Technical Note No. 1000/50

TM1000-50 FE-29-01

Subject : Free play in automatic elevator hook-up, adjustment

Effectivity type: DG-1000

Figure 2, looking from the rear into the gap at the right-hand side in front of the rudder

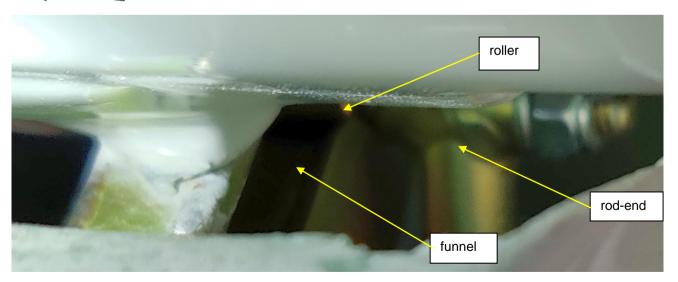
2.5 Rig the horizontal tailplane and when moving it backwards, monitor if you need a higher force. By lifting the elevator trailing edge and looking from the rear into the gap at the right-hand side in front of the rudder, check if the roller is moved up to the front end of the funnel, see also photo at the end of the TN Check the elevator displacements and adjust if necessary.
